# IREDELL COUNTY HEALTH DEPARTMENT

## IMPROVEMENT PERMIT / AUTHORIZATION TO CONSTRUCT / OPERATION PERMIT / EXISTING SYSTEM INSPECTION

PERMIT# 093540 PIN# 4629428292 DATE 8-30-99

INITIAL SITE SKETCH

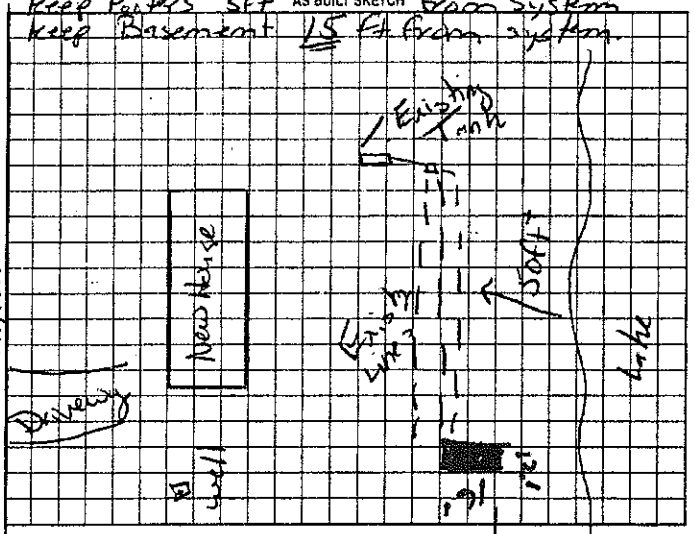
Comments /Conditions: Original Permit sized for 2 Bedrooms. Existing System Check - System Tank is deep - Recommend pumping Tank

AS BUILT SKETCH Keep System from Keep Basement 15 Ft from system. Keep Footers 5Ft
